SUMMARY NOTES OF THE FEBRUARY 12, 2014, MEETING OF THE ROOT RIVER WATERSHED RESTORATION PLAN ADVISORY GROUP

**REVIEW OF PARTIAL PRELIMINARY DRAFT CHAPTER VI,
"RECOMMENDED PLAN," OF SEWRPC COMMUNITY
ASSISTANCE PLANNING REPORT NO. 316 (CAPR NO. 316),
"A RESTORATION PLAN FOR THE ROOT RIVER WATERSHED"**

PROJECTS WITHIN THE ROOT RIVER WATERSHED

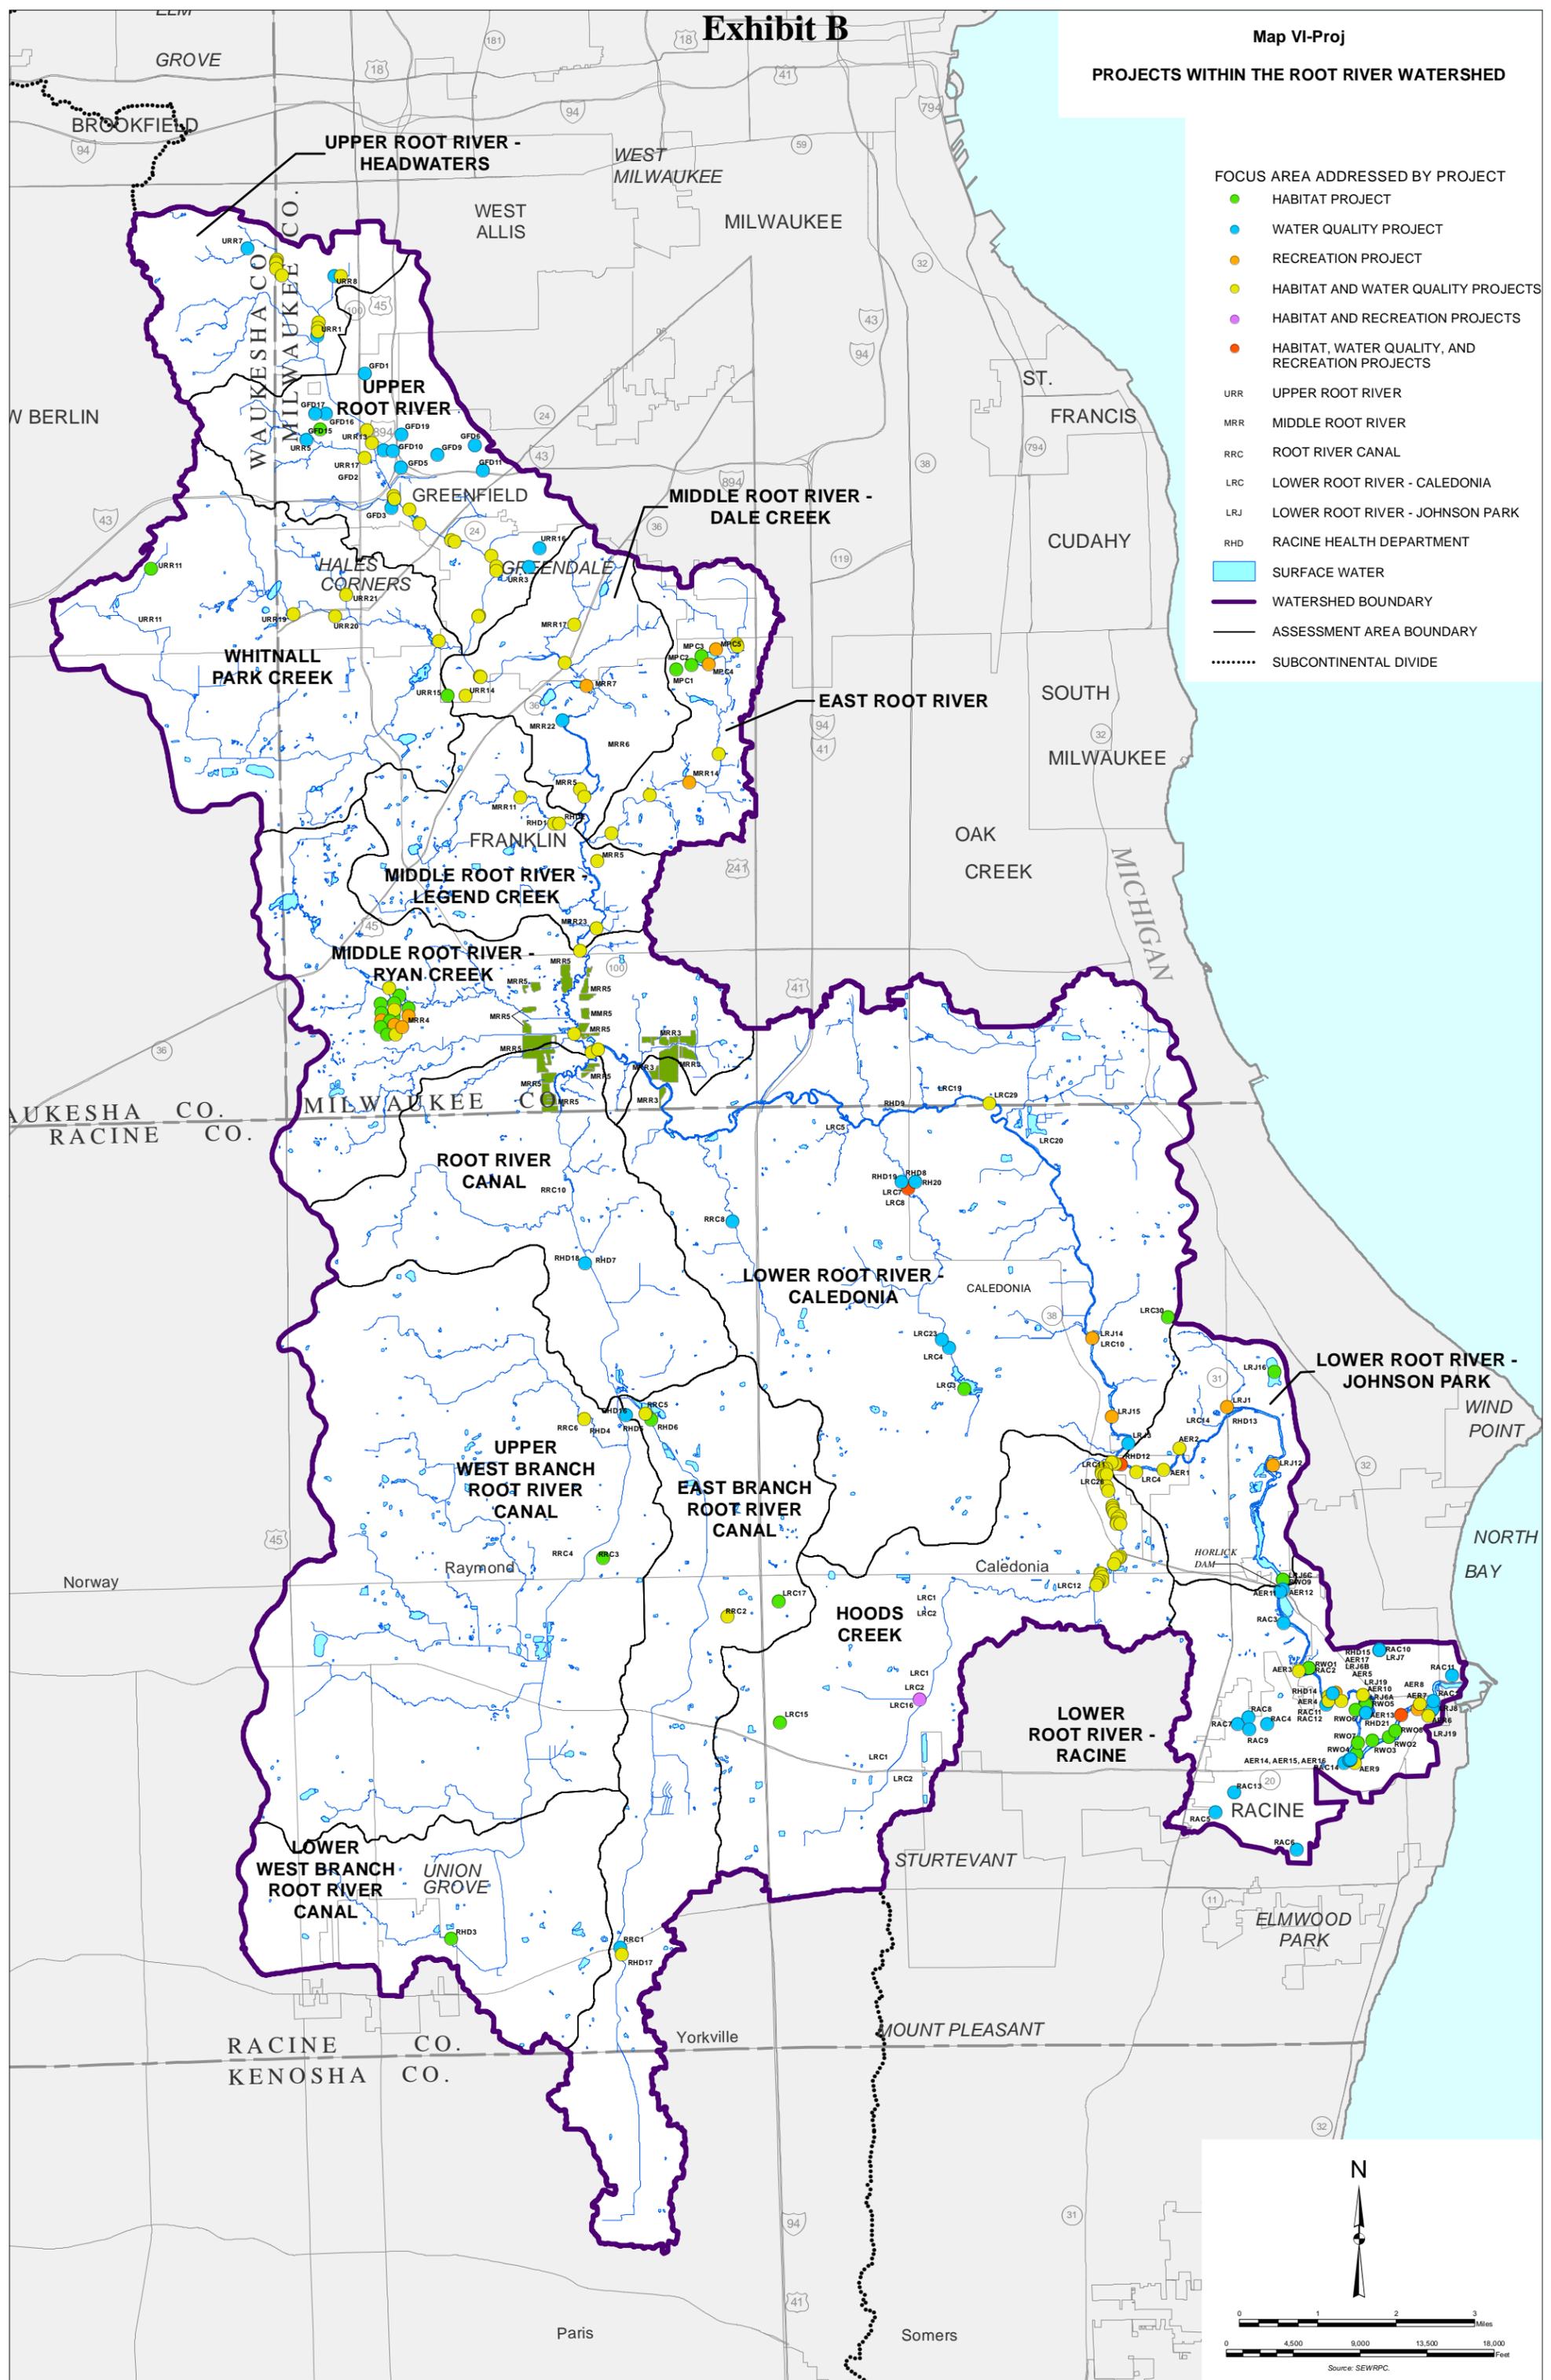
Dr. Boxhorn noted that the project map indicated the areal extent of certain Milwaukee County-owned lands that are candidate sites for riparian buffer habitat restoration or maintenance, rather than showing them as point features. He also noted that the SEWRPC staff was still looking for and assessing projects to be added to the table, and he asked the Advisory Group members to provide any suggestions that they may have.

Mr. Russart asked that the project map legend include a specific item for the County-owned lands delineated on the map, and that the location of Site ID No. MRR-04 on page three of the draft project table be given as “Franklin Savanna State Natural Area.” He also said that there is a restoration plan for the Franklin Savanna, there is County-owned agricultural land adjacent to the Savanna that should be mapped, and the Savanna should be designated in the table and on the map as relating to the water quality (land surface erosion reduction) and habitat focus areas, as well as the recreational use and access focus area. He asked that Grobschmidt Park be added to the table and on the map, and that it be designated as addressing the habitat focus area. Finally, he requested that Milwaukee County be added as a responsible party for ID No. MRR-23, Hidden Oaks Savanna, on page four of the table, and that the management actions in the table for ID Nos. URR-14, Whitnall Park, and URR-15, Mangan Woods, be switched.

Ms. Warner asked that the ongoing “Weed-out Racine” invasive species management project be mentioned in the plan, noting that such a reference will help in obtaining grant funding. She said she would provide information on the program to Dr. Boxhorn. Mr. Martinka supported Ms. Warner’s request, noting that funders look favorably on projects recommended under planning efforts such as this restoration plan.

Mr. Sampson said that he would provide the SEWRPC staff with information on Racine County agricultural management practices proposed to be implemented from 2014 through 2015.

[Secretary's Note: The "Weed-out Racine" invasive species management projects and the Racine County agricultural management practices were added to Table VI-Proj and the accompanying project map (see Exhibits A and B).]

[Secretary’s Note: Table VI-Proj and the accompanying project map were revised to include the Horlick dam (see Exhibits A and B).]
